**FORT DEVENS
FEASIBILITY STUDY
FOR GROUPS 2 & 7 SITES**

**FINAL
FEASIBILITY STUDY REPORT
AREA OF CONTAMINATION (AOC) 43J**

ABB Environmental Services, Inc.
Wakefield, Massachusetts
Project No. 07053-11

FIGURE 2-1
DISTRIBUTION OF ORGANIC GROUNDWATER
CONTAMINATION ABOVE MCL ON 3/95
AOC 43J-HISTORIC GAS STATION J
FEASIBILITY STUDY REPORT
FORT DEVENS, MA

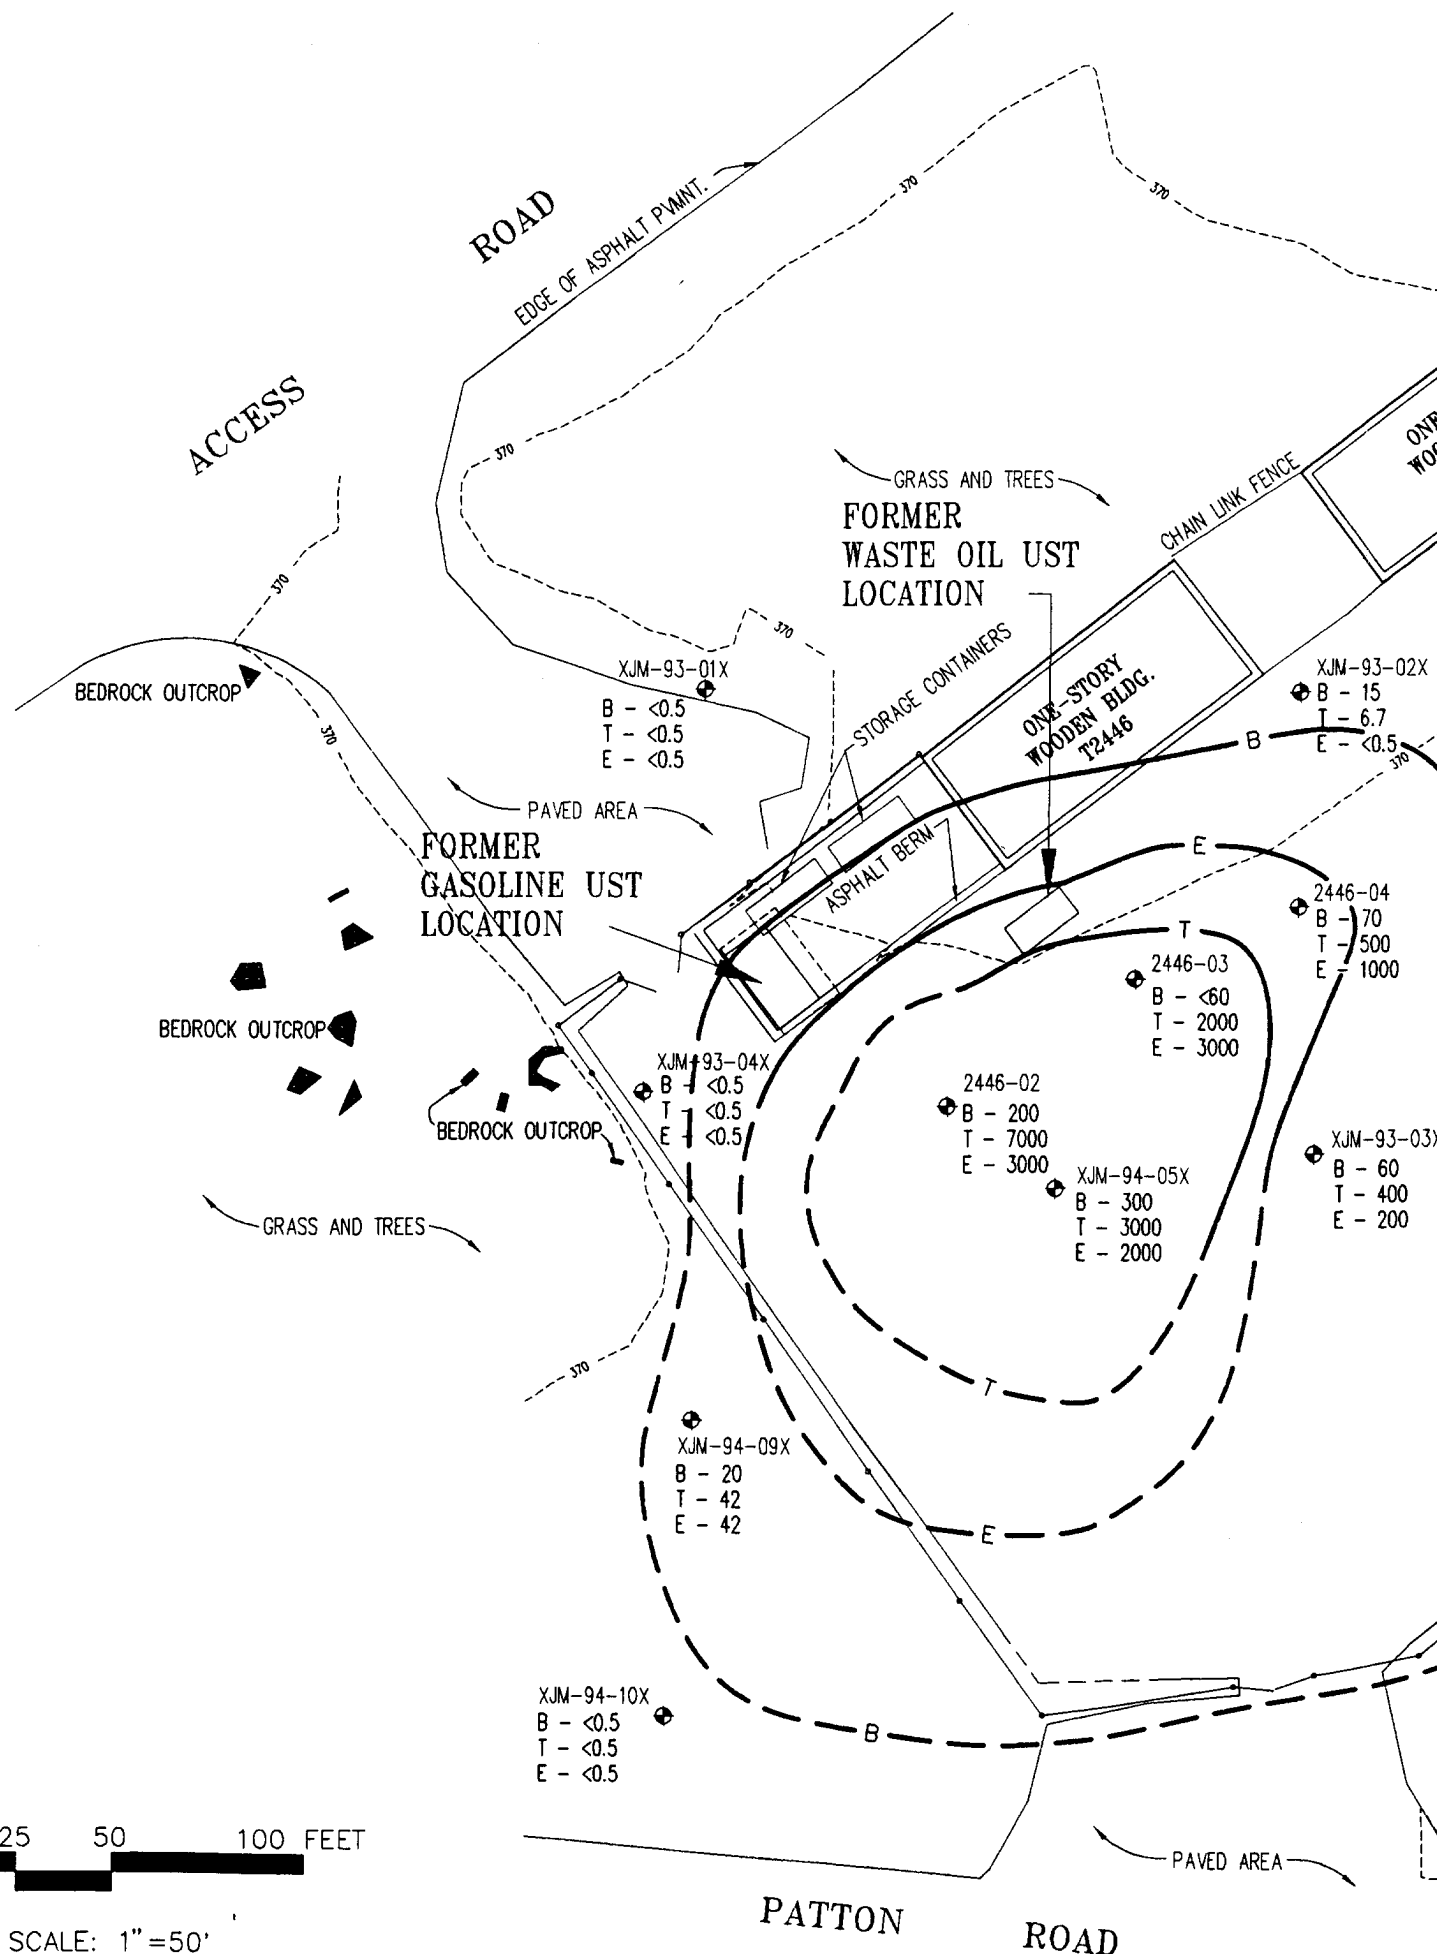
1. Comment: Establishing a case for intrinsic bioremediation (Table 2-3 and Figure 2-1 were consulted in formulating this comment). The demonstration of the occurrence of intrinsic bioremediation is insubstantial and contains inconsistencies. Table 2-3 shows the expected trend of increasing redox potential, increasing nitrate concentration, and increasing phosphate concentration moving down gradient from the source within the organic plume. However, the lowest sulfate concentration was observed at the down gradient edge of the plume rather than at the center of the plume. Furthermore, chloride concentrations, which should remain fairly constant within the aquifer, are significantly lower in the down gradient plume and down gradient edge. Thus, other phenomena may also be occurring which would then be obscuring some of the alleged biodegradation effects. Please address these inconsistencies in the FS.

FIGURE 2-2
DISTRIBUTION OF ORGANIC GROUNDWATER
CONTAMINATION ABOVE MCL ON 12/94
AOC 43J-HISTORIC GAS STATION J
FEASIBILITY STUDY REPORT
FORT DEVENS, MA

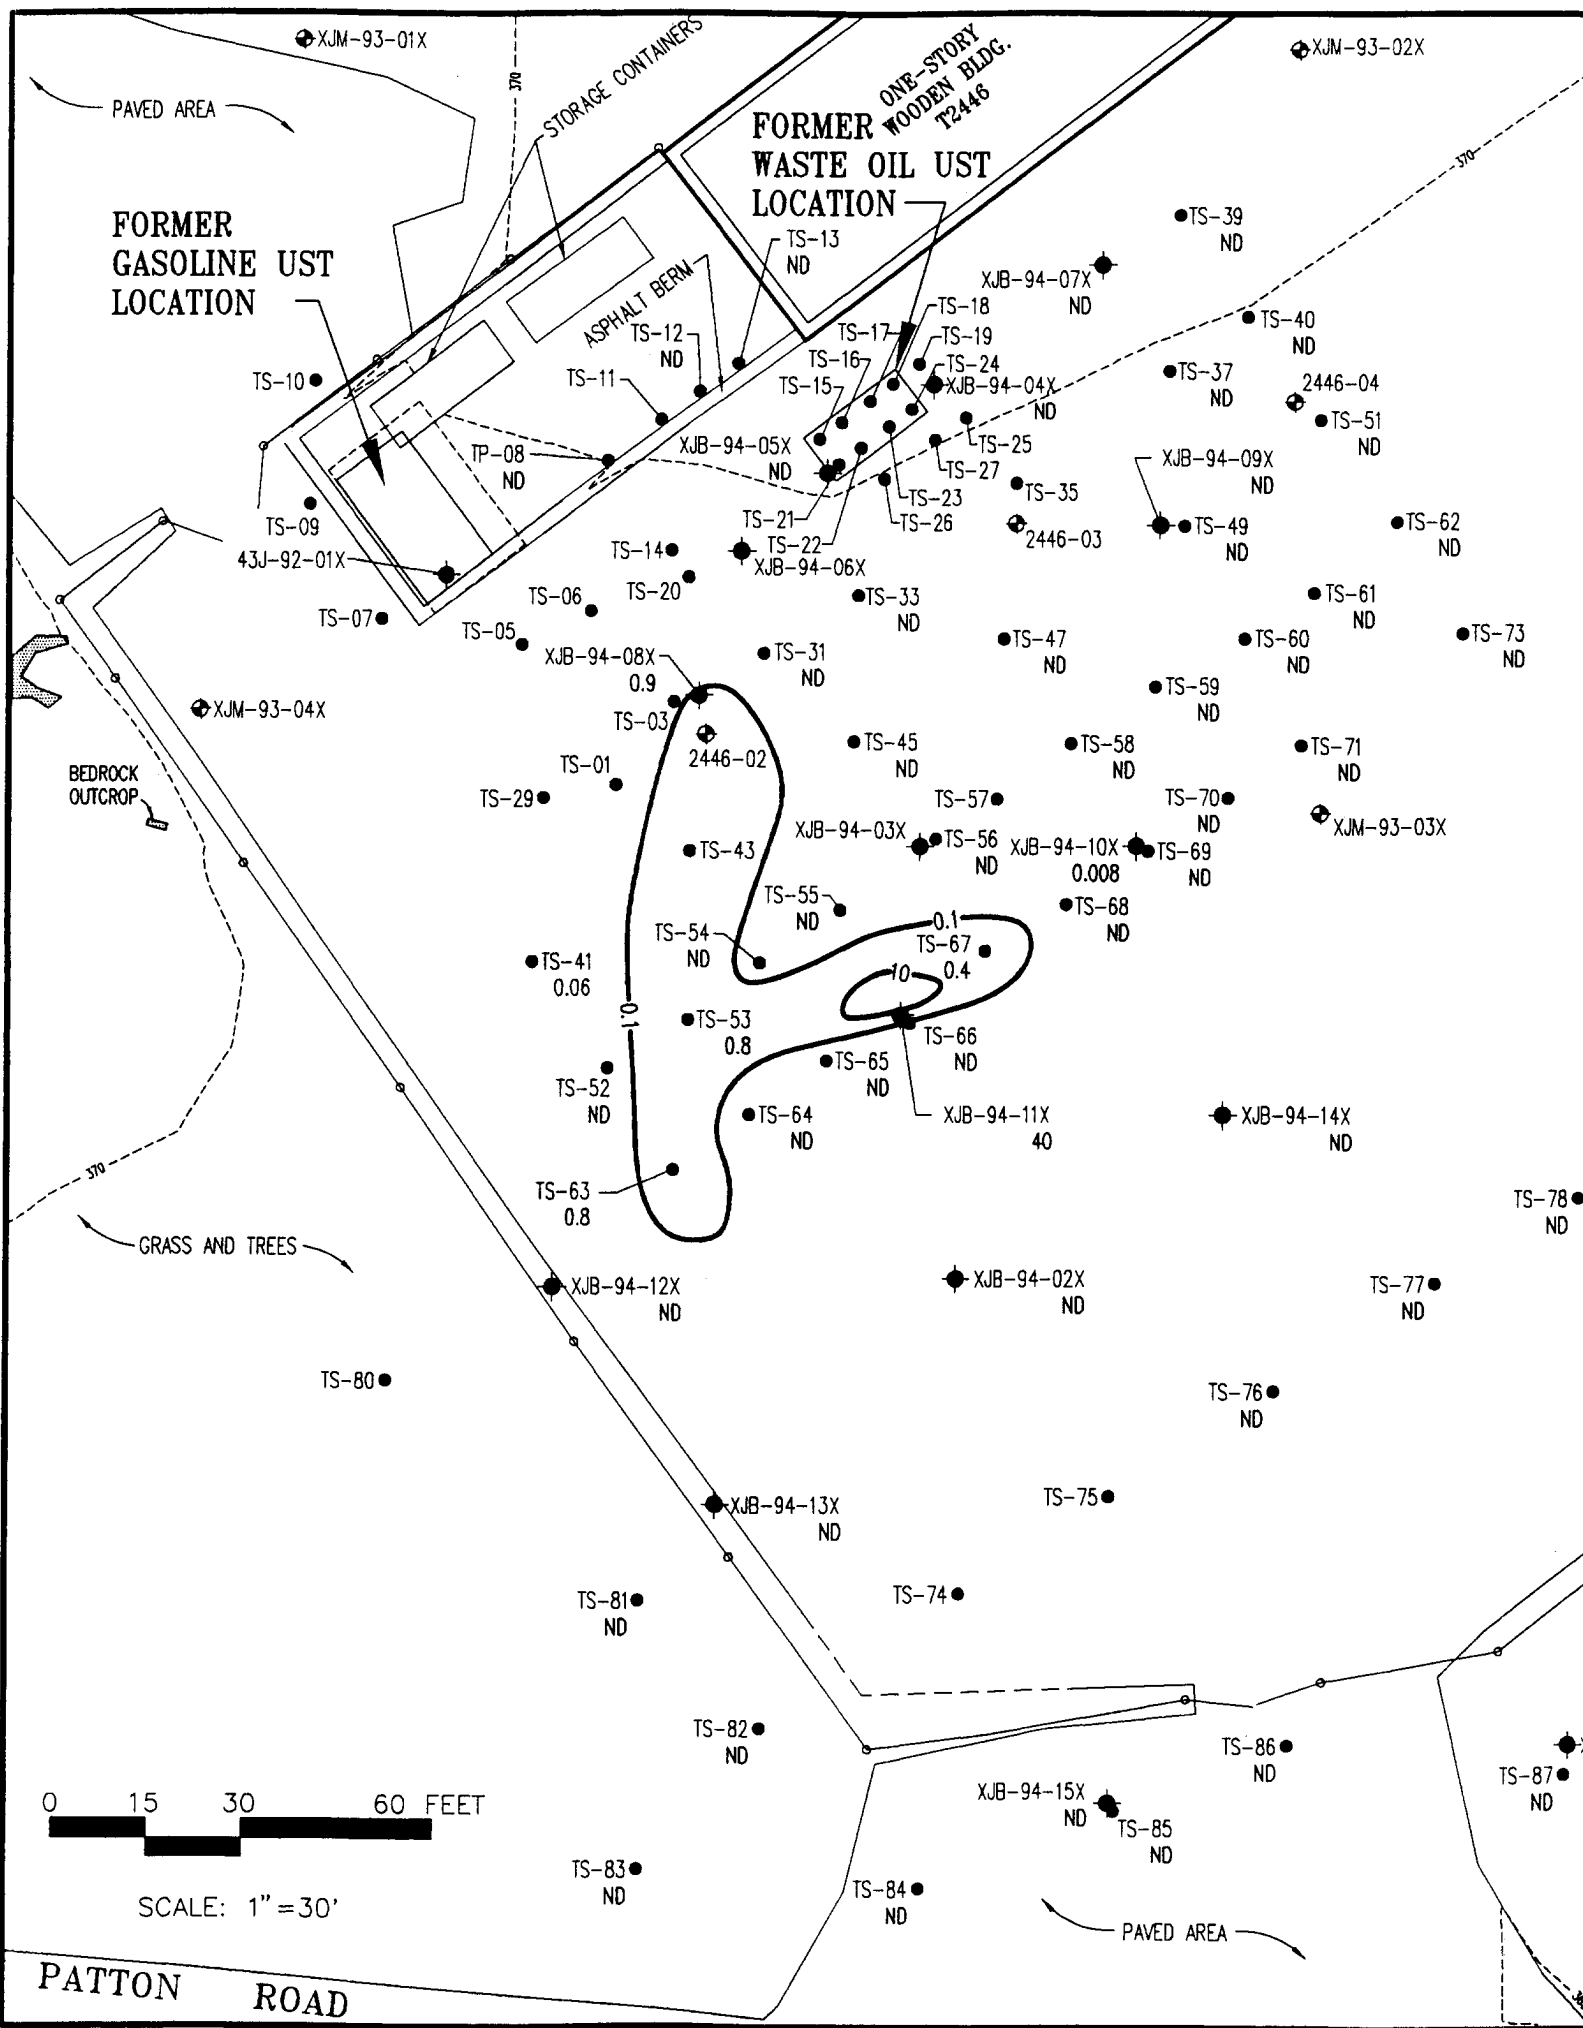
1. Comment: Establishing a case for intrinsic bioremediation (Table 2-3 and Figure 2-2 were consulted in formulating this comment). The demonstration of the occurrence of intrinsic bioremediation is weak and contains inconsistencies. The case for intrinsic bioremediation is made based solely on indirect evidence. Table 2-3 shows the expected trend of increasing redox potential moving down-gradient from the source within the organic plume. However, the lowest nitrate, sulfate, and phosphate concentrations were observed at the downgradient edge of the plume rather than at the center of the plume as would be expected. This is inconsistent and requires at least a speculative explanation. Furthermore, chloride concentrations, which should remain fairly constant within the aquifer, are significantly lower in the upgradient well. Thus, other phenomena may also be occurring which would then be obscuring some of the alleged biodegradation effects. This inconsistency should be addressed.

Response: Because the "source area" wells may actually be slightly upgradient of the true center of the plume (as noted by the soil concentration contours in Figure 2-3 through 2-8), nitrate, sulfate and phosphate concentrations may decrease farther downgradient as appears to be observed in downgradient wells. Lovely, Chapelle, and Woodward (Lovely, 1994) note that when shallow aquifers are heavily contaminated with organic compounds, it is generally difficult to delineate the distribution of the anoxic redox processes. They further state that reduced products that are actively produced near the source of organic contamination may persist in the groundwater as it moves downgradient into areas where there is little or no ongoing production of these compounds. Therefore observation of reduced nitrate, phosphate and sulfate are not necessarily inconsistent with expected trends and does not negate the evidence that biodegradation is occurring at the site.

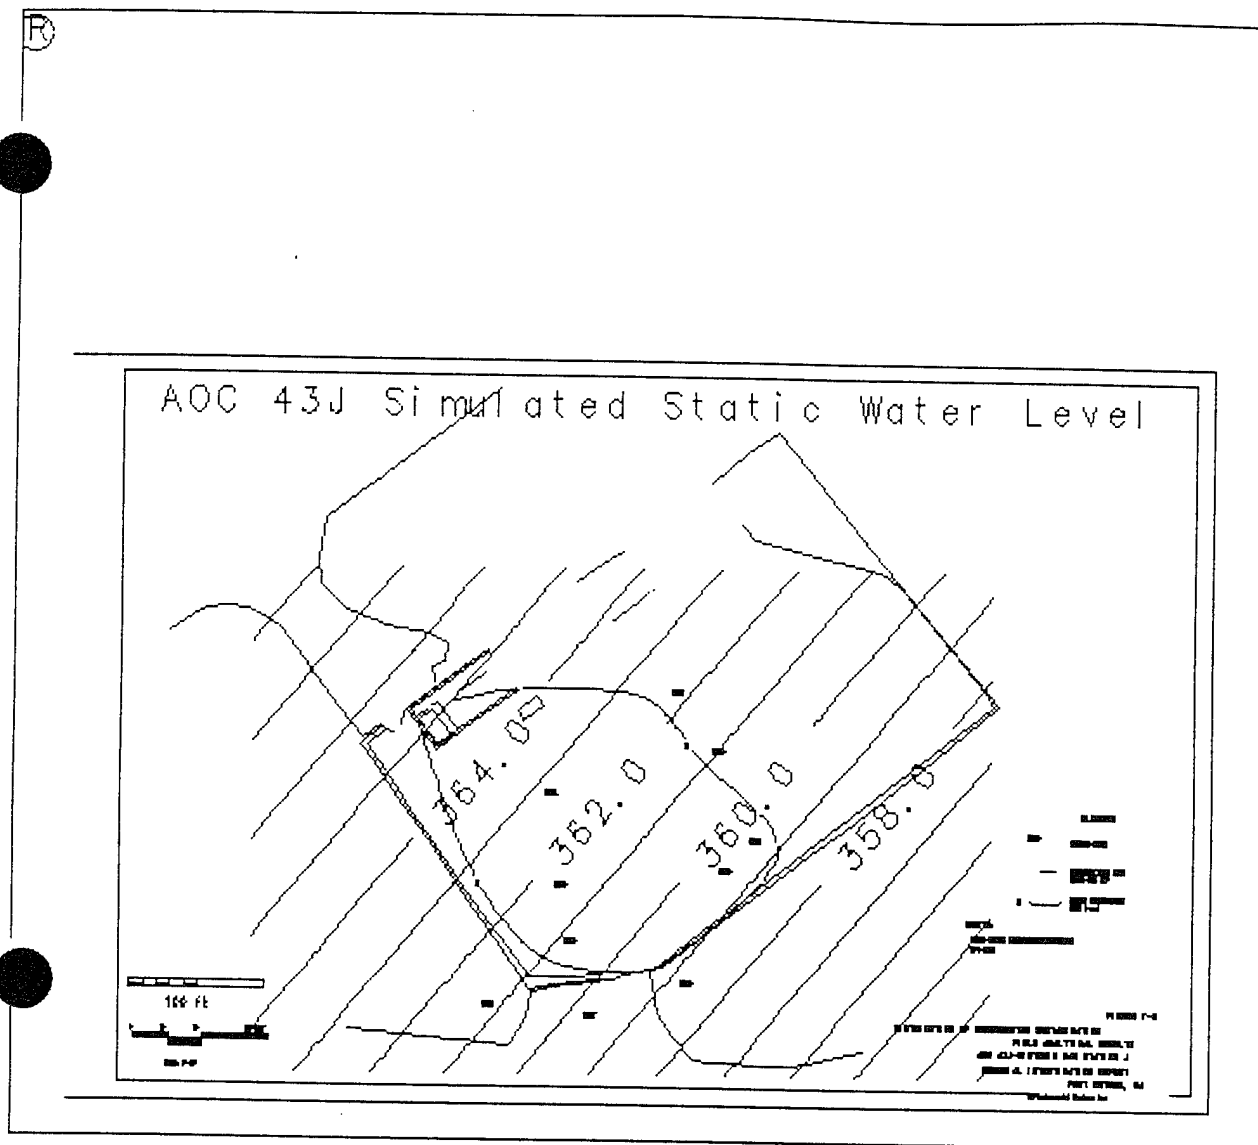
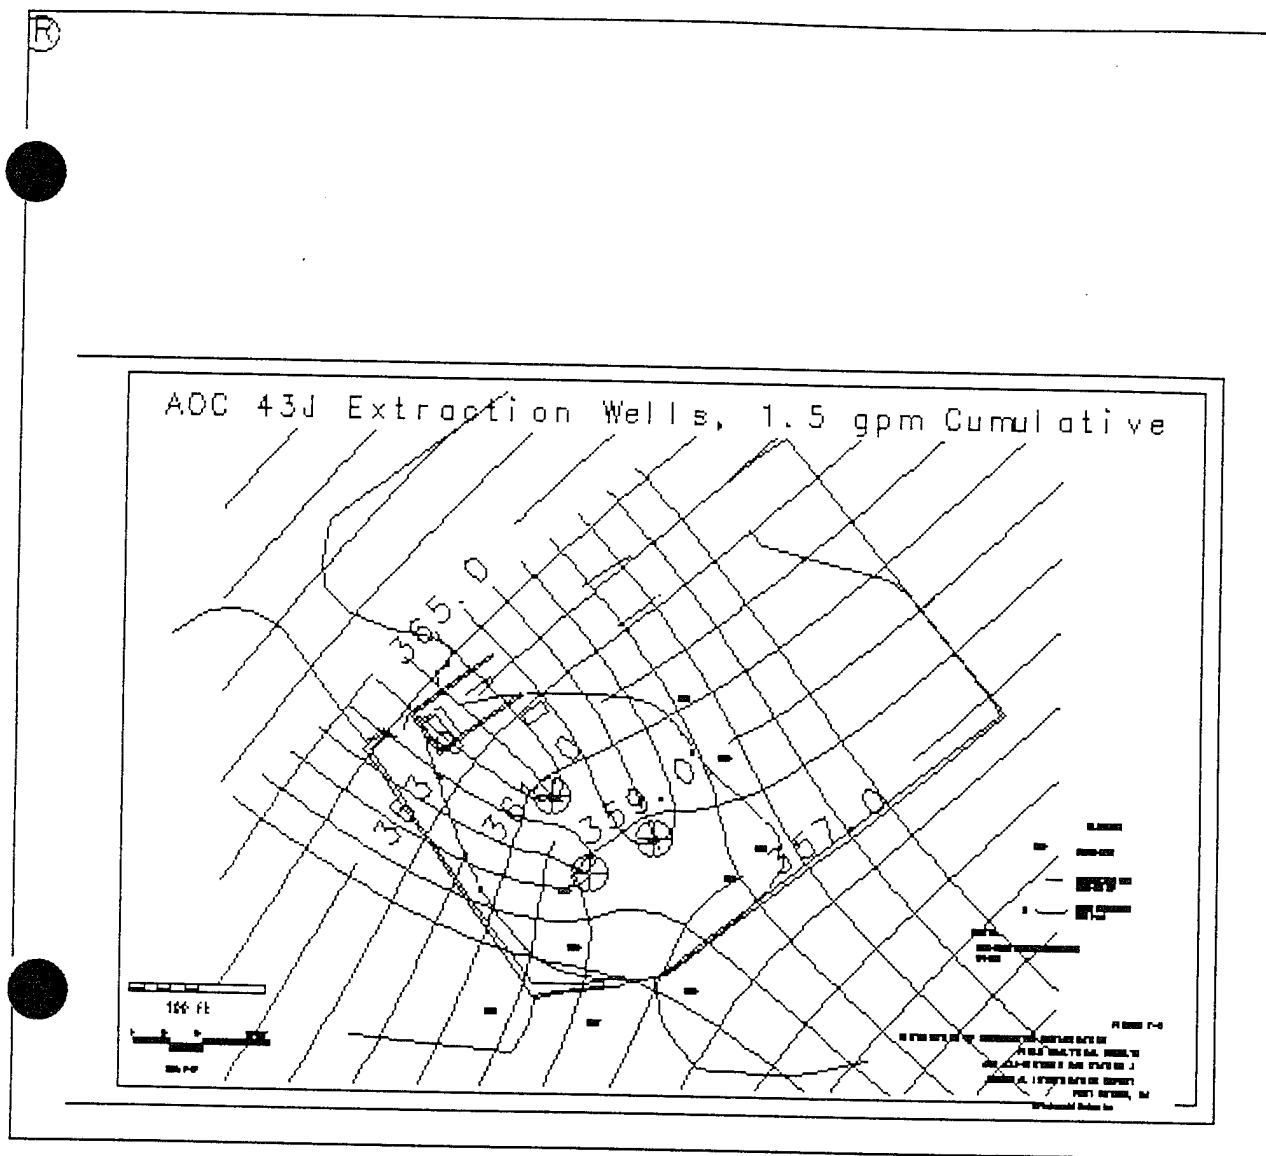
13. Comment: **Appendix B, Figures 1, 2, & 3.** Much of the text and characters in these figures are illegible. These figures should be presented in a larger format.

Response: The Quickflow model's graphics resolution using converted Autocad drawings as presented in Figures 1, 2, and 3 cannot be improved. All the relevant data for review of the model output (well location, groundwater elevations, and flow) are clearly depicted. The remaining typed text or site features that are lost due to poor resolution are not pertinent to the overall model evaluation.

FIGURE 2

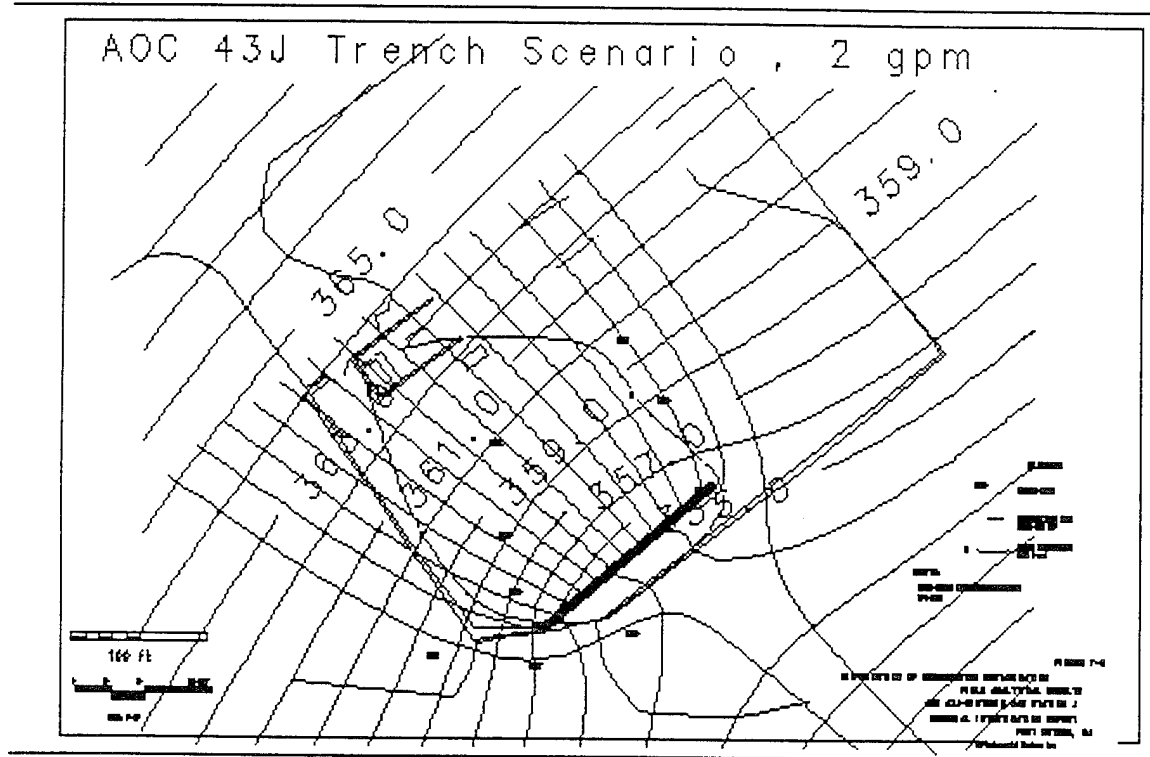
12. Comment: **Appendix A. Figure 2:** The groundwater contours produced under pumping conditions indicate the groundwater table will be at or below the bedrock/overburden contact in the area of the pumping wells. It appears the overburden will be dewatered and the wells will be collecting groundwater controlled by the bedrock geology (i.e. fractures, joints, etc.). As indicated in the pump

Figure 2 needs to be revised such that the elevations of the contours are legible and the identities of the wells used to generate the contour are shown.

Figure 2 contour elevations will be made more legible. Identifying specific wells would only make the figure less legible. Figure 2 states that contours are based on the May 9, 1995 water level measurements. The reader can readily reference Figure 1-10 for monitoring well identification.
